Ref: 41-111-110 Retaining Wall Demo and Replacement – 119 Somerset Road, Sandy's

This Addendum #1 contains (4) pages including this front page.

### Site Map

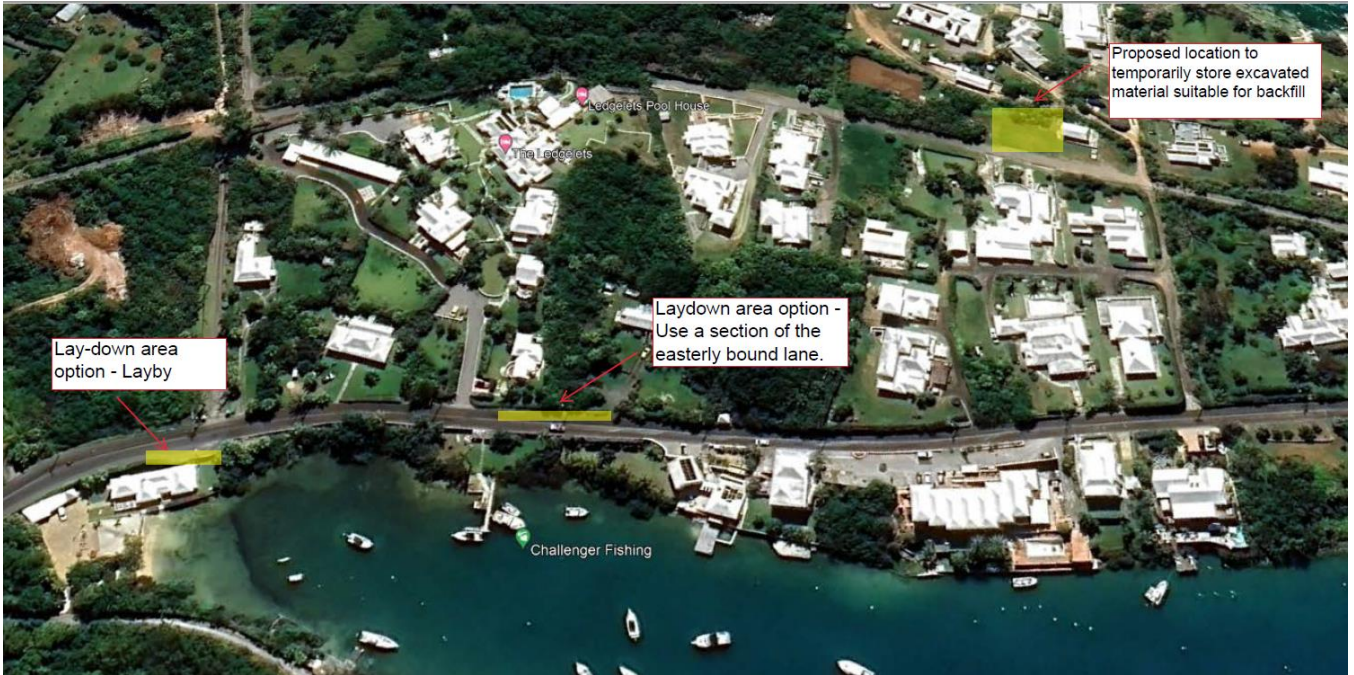
2. Q) Are we to price the removal of the fuel tank?  
A) The fuel tank will be removed by others prior to the start of this project.
3. Q) What area is designated for laydown area for the duration of the project

A) See photo below showing the various laydown areas that can be used.
4. Q) What restrictions will be put in place during the project for 40' trailers needing to pass by the site?

5. Q) Are there any areas near by the site that we can temporarily store suitable backfill material that is excavated from site?  
A) See below photo which shows a proposed site adjacent to the Somerset Bridge Railway Station on the Railway Trail. We are seeking confirmation on the use of this location and will provide confirmation in due course.
